## **Proposed Lower Ground Floor**

date 25.04.04 by VV dwg title Proposed Lower GF project no. 2407 dwg no. 02-299

Cooper status Planning project 38 Great James Street date January 2025 scale 1:100@A3 / 1:50@A1

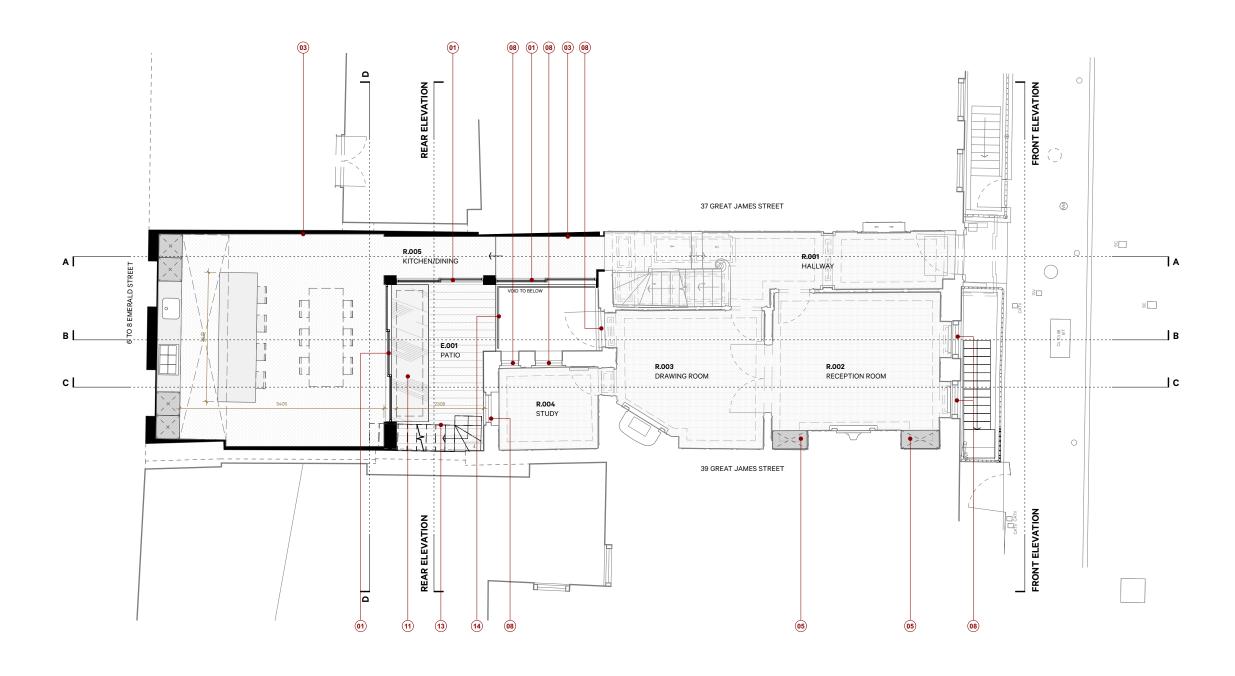
Omission of fireplace proposals;
Omission of LGF and 3rd floor layout proposals;
Omission of changes to 2nd floor bathroom;
Omission of heat pump proposals;
Omission of ground floor opening proposals;
rev A note Introduction of sloped roof to 4th floor terrace;

dwg title Proposed GF Plan project no. 2407 dwg no. 02-300 Cooper status Planning project 38 Great James Street scale 1:100@A3 / 1:50@A1

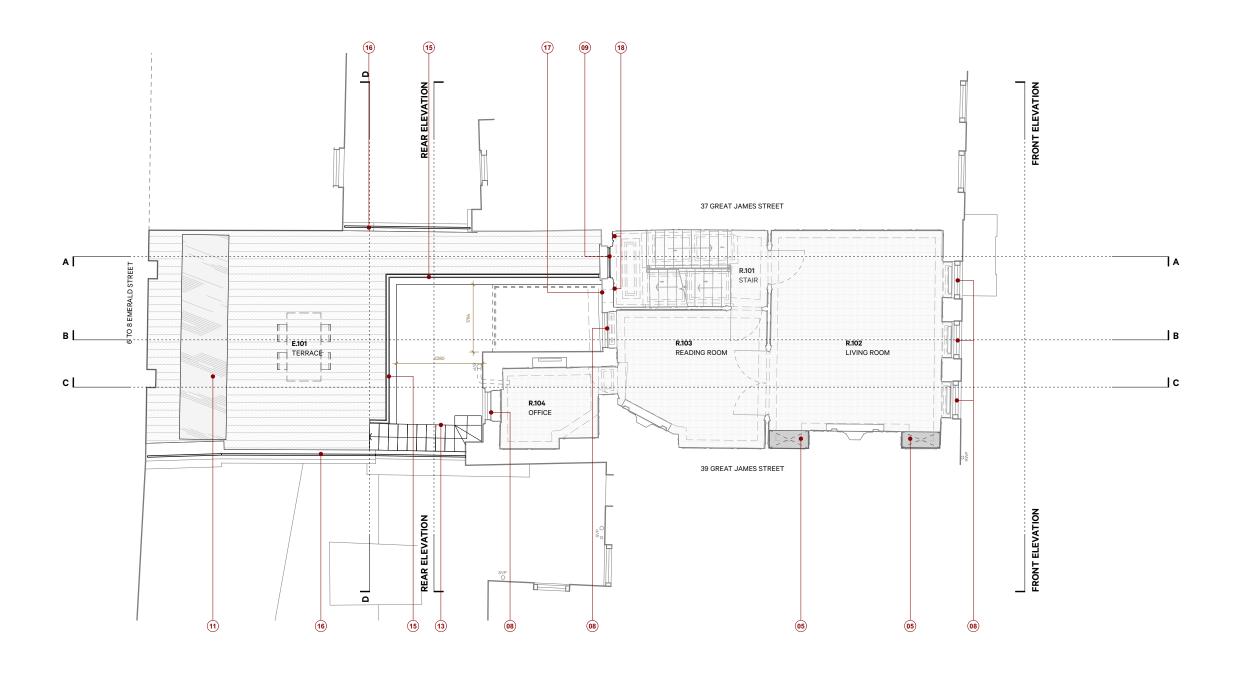
Omission of fireplace proposals;
Omission of LGF and 3rd floor layout proposals;
Omission of changes to 2nd floor bathroom;
Omission of heat pump proposals;
Omission of ground floor opening proposals;
rev A note Introduction of sloped roof to 4th floor terrace;

dwg title Proposed 1F Plan project no. 2407 dwg no. 02-301 client Cooper status Planning project 38 Great James Street scale 1:100@A3 / 1:50@A1

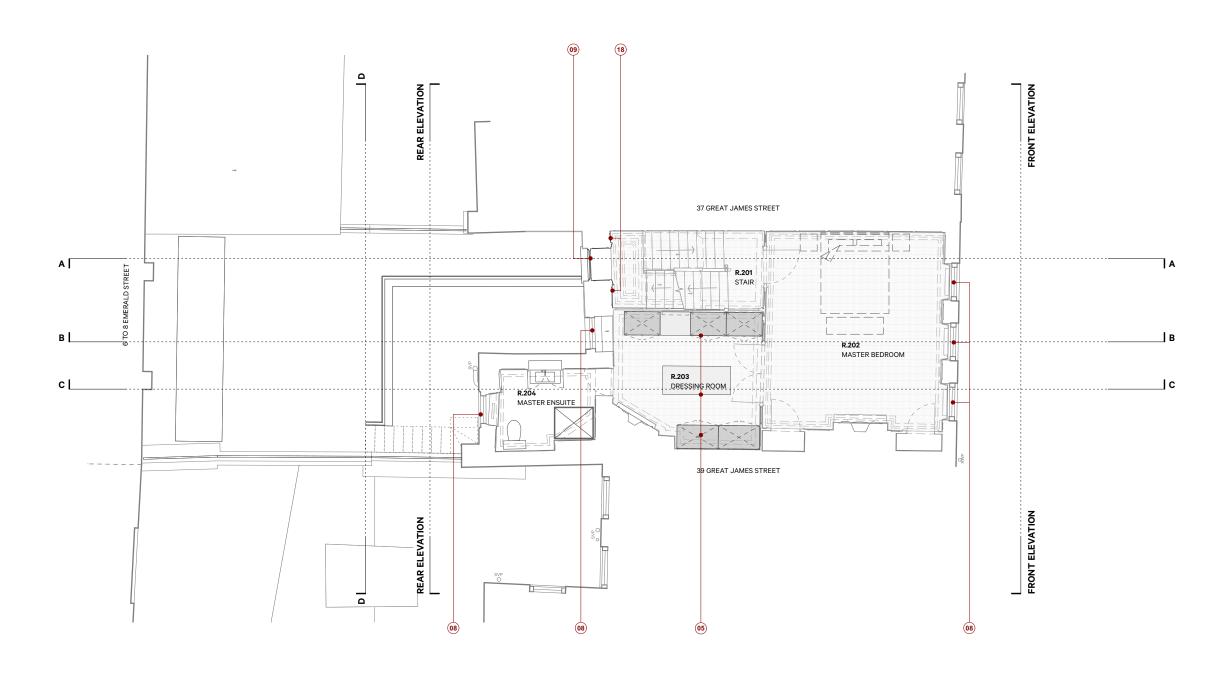
Omission of fireplace proposals;
Omission of LGF and 3rd floor layout proposals;
Omission of changes to 2nd floor bathroom;
Omission of heat pump proposals;
Omission of ground floor opening proposals;
rev A note Introduction of sloped roof to 4th floor terrace;

dwg title Proposed 2F Plan project no. 2407 dwg no. 02-302

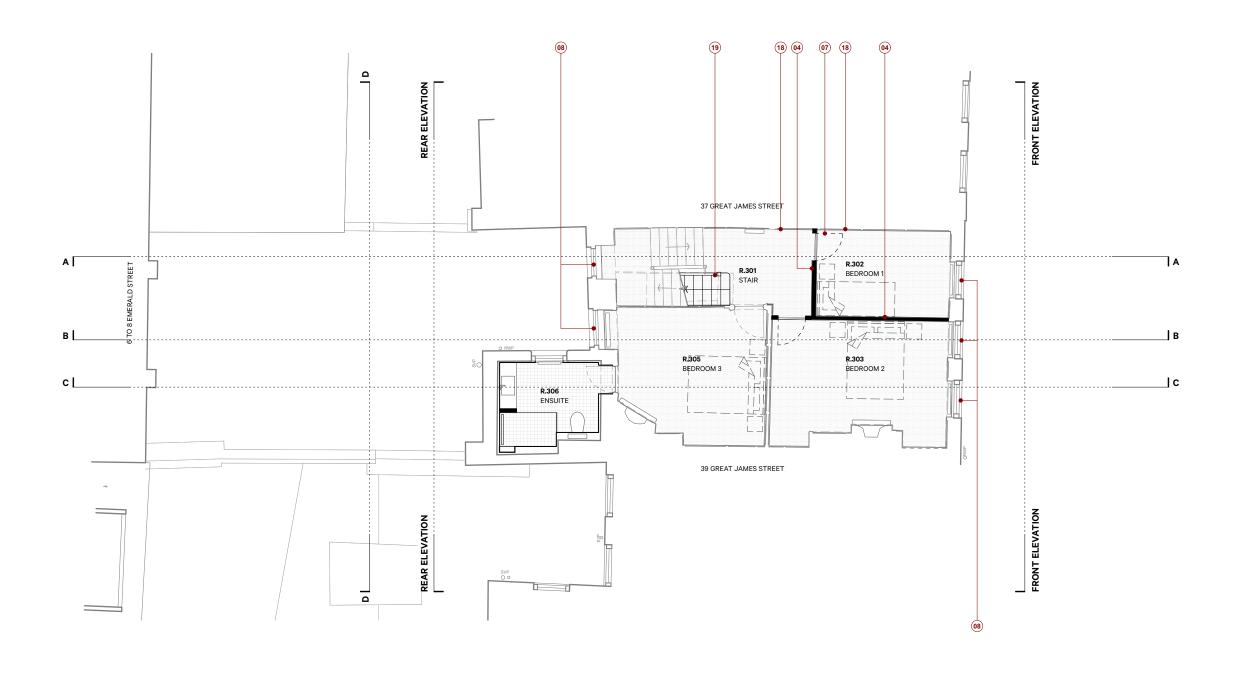
Omission of fireplace proposals;
Omission of LGF and 3rd floor layout proposals;
Omission of changes to 2nd floor bathroom;
Omission of heat pump proposals;
Omission of ground floor opening proposals;
rev A note Introduction of sloped roof to 4th floor terrace;

dwg title Proposed 3F Plan project no. 2407 dwg no. 02-303 client Cooper status Planning project 38 Great James Street scale 1:100@A3 / 1:50@A1

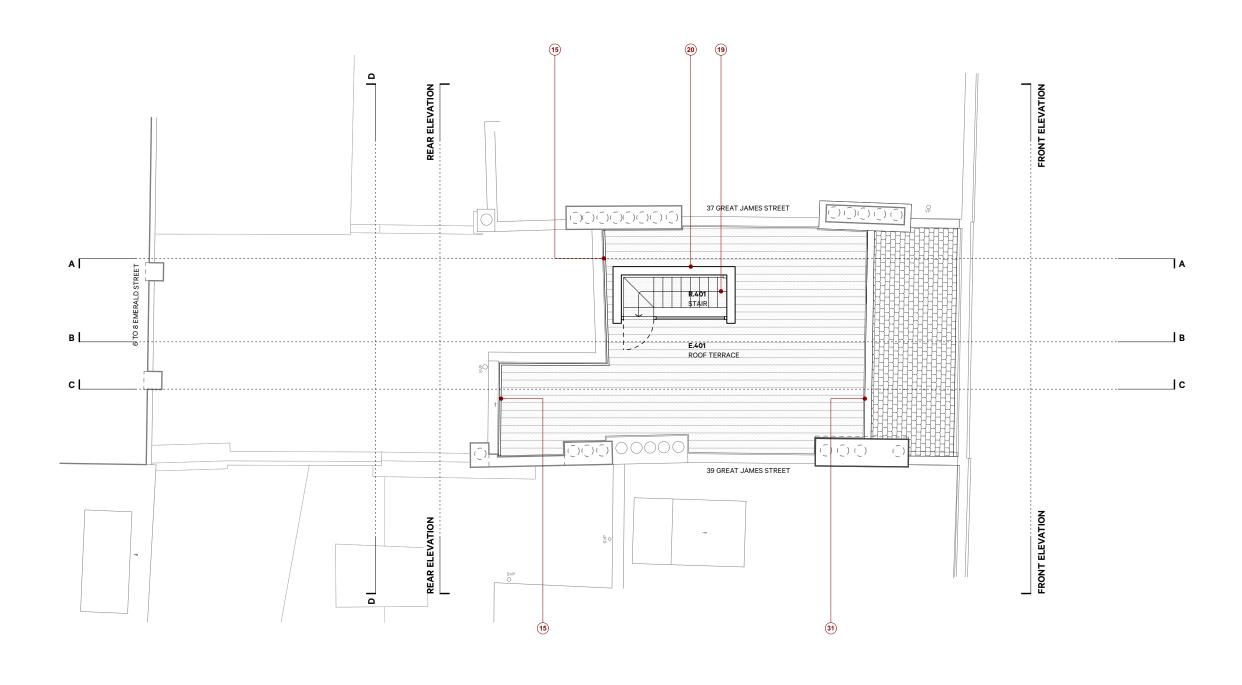
Omission of fireplace proposals;
Omission of LGF and 3rd floor layout proposals;
Omission of changes to 2nd floor bathroom;
Omission of heat pump proposals;
Omission of ground floor opening proposals;
rev A note Introduction of sloped roof to 4th floor terrace;

date 25.04.04 by VV dwg title Proposed 4F Plan project no. 2407 dwg no. 02-304

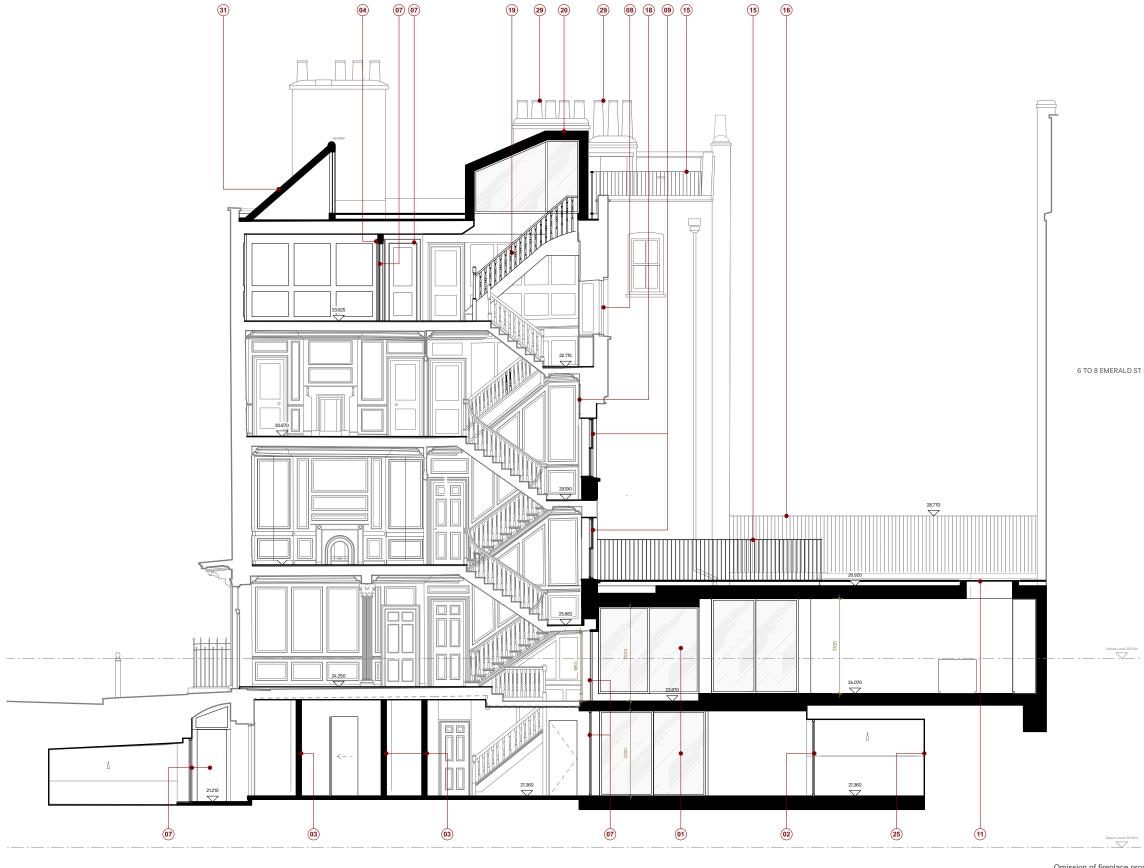
Omission of fireplace proposals;
Omission of LGF and 3rd floor layout proposals;
Omission of changes to 2nd floor bathroom;
Omission of heat pump proposals;
Omission of ground floor opening proposals;
rev A note Introduction of sloped roof to 4th floor terrace;

dwg title Proposed Section A-A project 2407 dwg no. 03-300

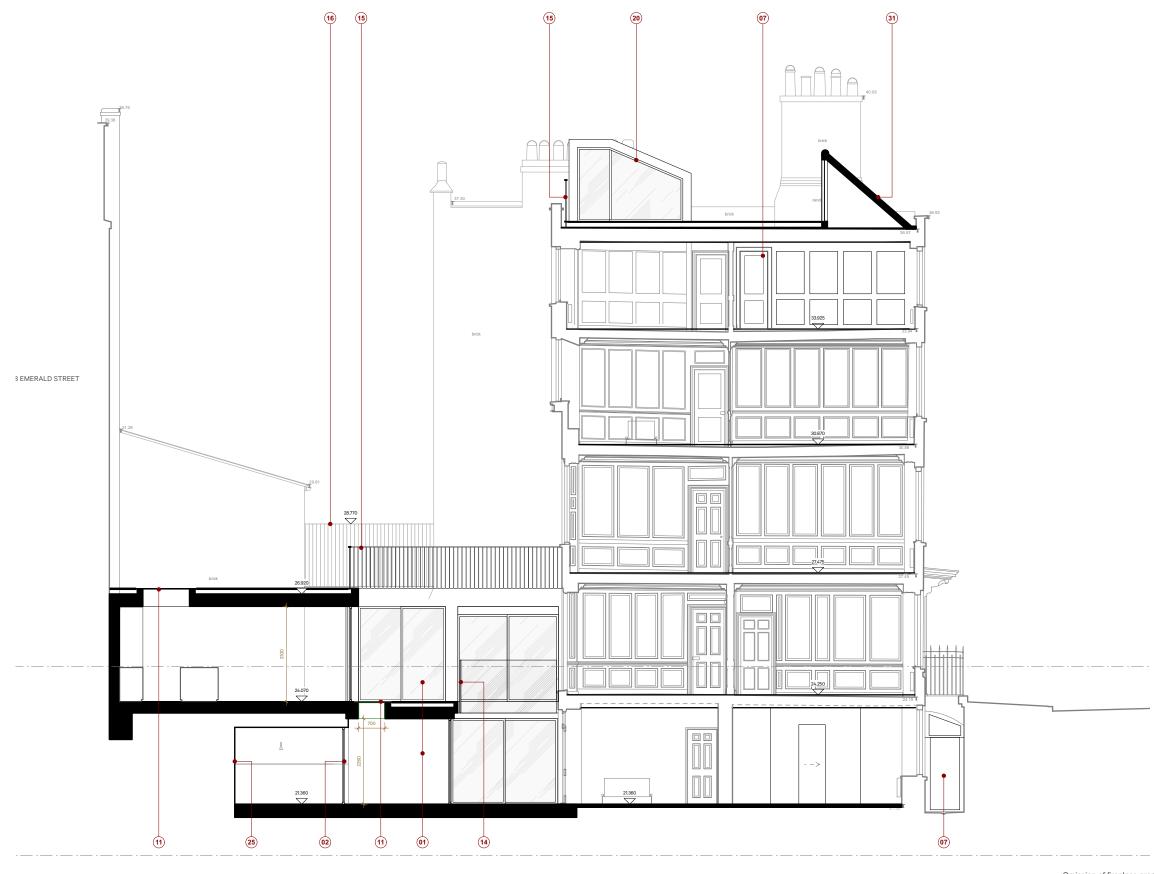
Omission of fireplace proposals;
Omission of LGF and 3rd floor layout proposals;
Omission of changes to 2nd floor bathroom;
Omission of heat pump proposals;
Omission of ground floor opening proposals;
rev A note Introduction of sloped roof to 4th floor terrace; date 25.04.04 by VV

title Proposed Section B-B project 2407 dwg no. 03-301

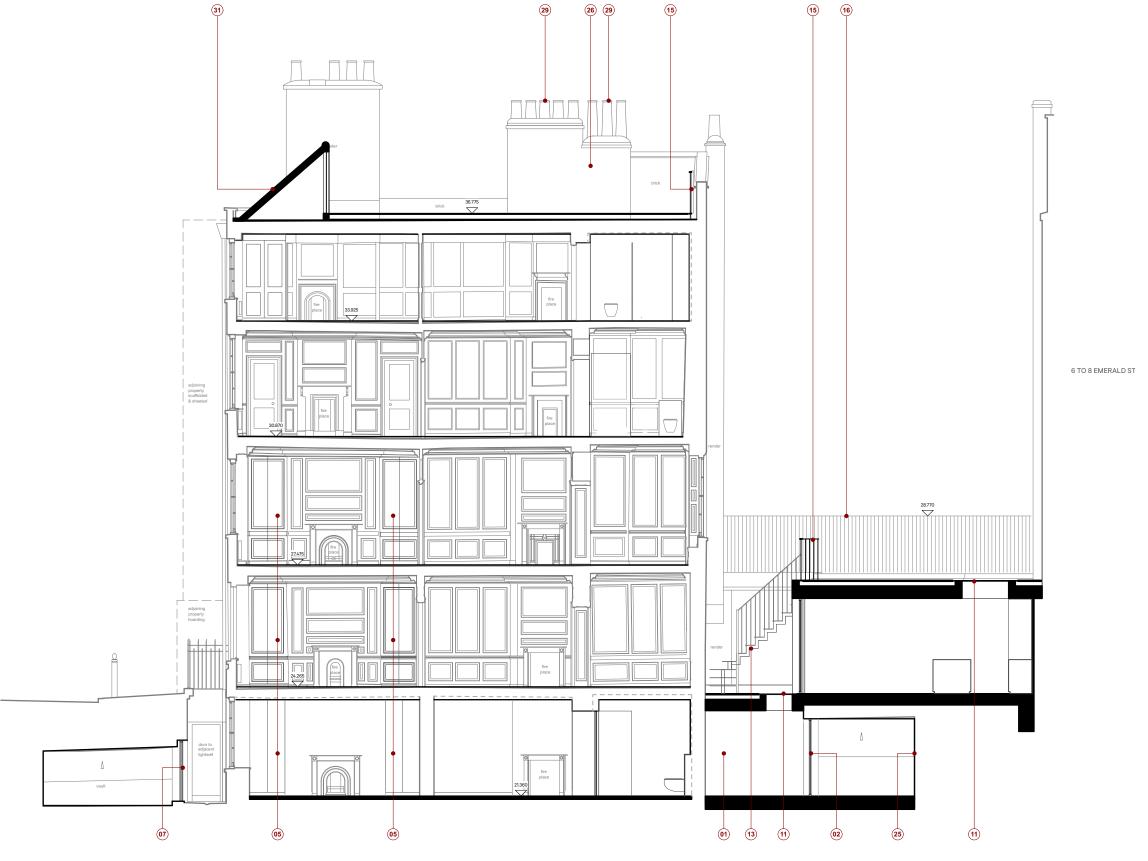
Omission of fireplace proposals;
Omission of LGF and 3rd floor layout proposals;
Omission of changes to 2nd floor bathroom;
Omission of heat pump proposals;
Omission of ground floor opening proposals;
rev A note Introduction of sloped roof to 4th floor terrace;

title Proposed Section C-C project 2407 client Cooper project 38 Great James Street status Planning date January 2025 scale 1:100@A3 / 1:50@A1

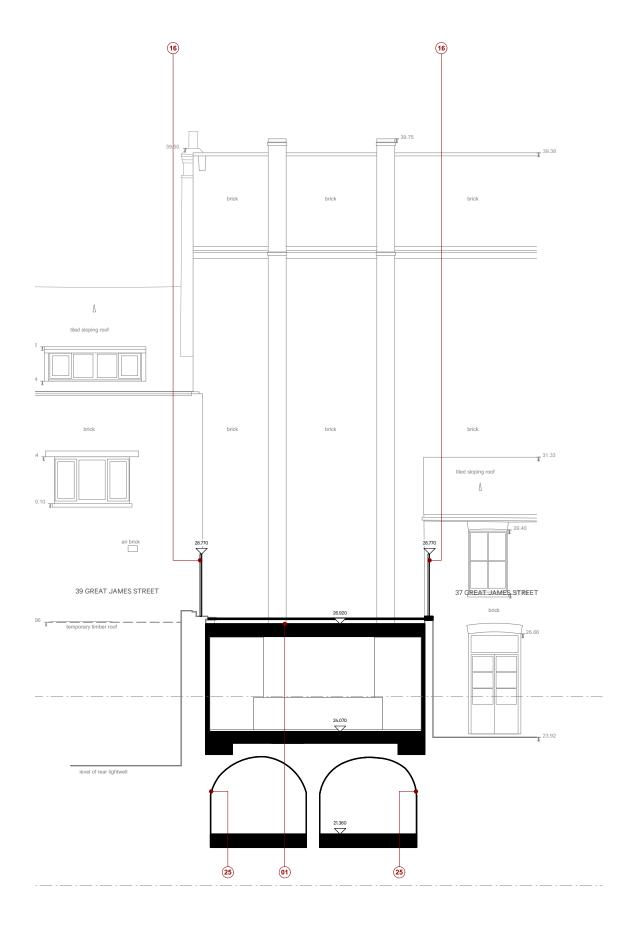
Omission of fireplace proposals;
Omission of LGF and 3rd floor layout proposals;
Omission of changes to 2nd floor bathroom;
Omission of heat pump proposals;
Omission of ground floor opening proposals;
rev A note Introduction of sloped roof to 4th floor terrace;

dwg title Proposed Section D-D project 2407

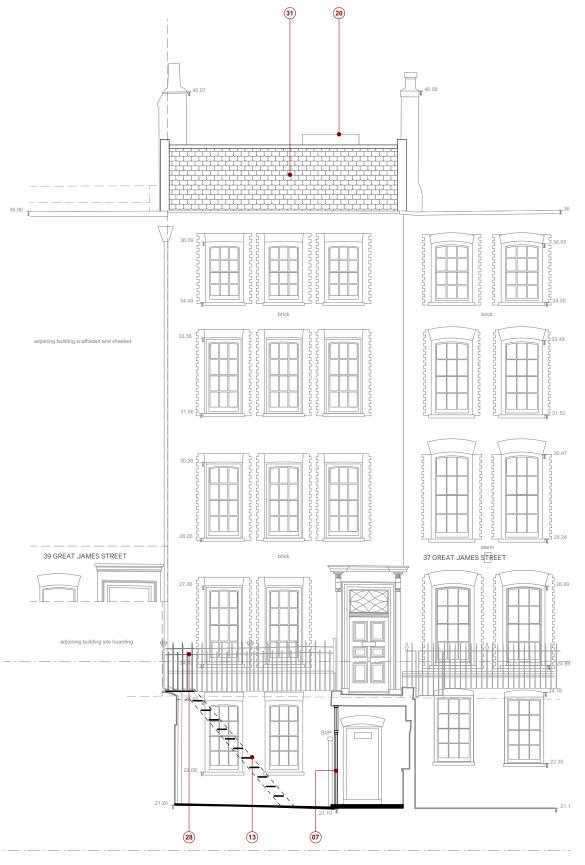
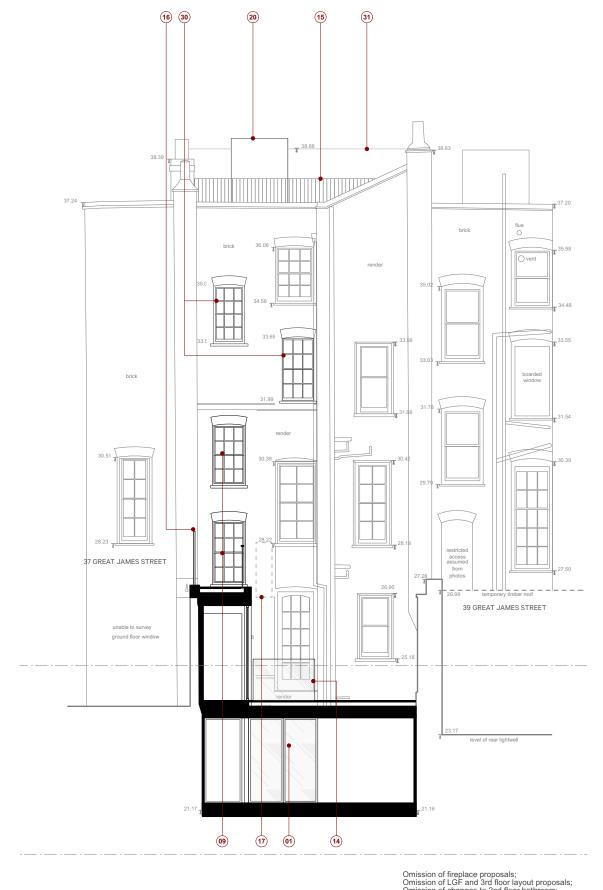
Omission of fireplace proposals;
Omission of LGF and 3rd floor layout proposals;
Omission of changes to 2nd floor bathroom;
Omission of heat pump proposals;
Omission of ground floor opening proposals;
rev A note Introduction of sloped roof to 4th floor terrace;
